UNITED STATES PATENT AND TRADEMARK OFFICE

Office Action Summary

10/023,430

DETAILED ACTION

FIG. 23

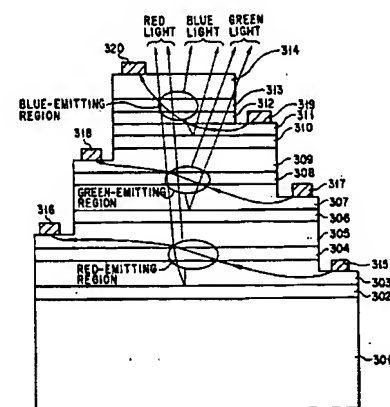
6. Claims 1-21 are rejected under 35 U.S.C. 102(b) as being anticipated by Ishikawa et al (5,696,389). Ishikawa et al discloses the claimed invention. Note figure 23 which illustrates an optoelectronic device comprising a substrate (301), a number of different active layers (304,308,313), a number of different barrier layers (303,305, 307, 309, 312,314), and contact means (315,316,318,320).
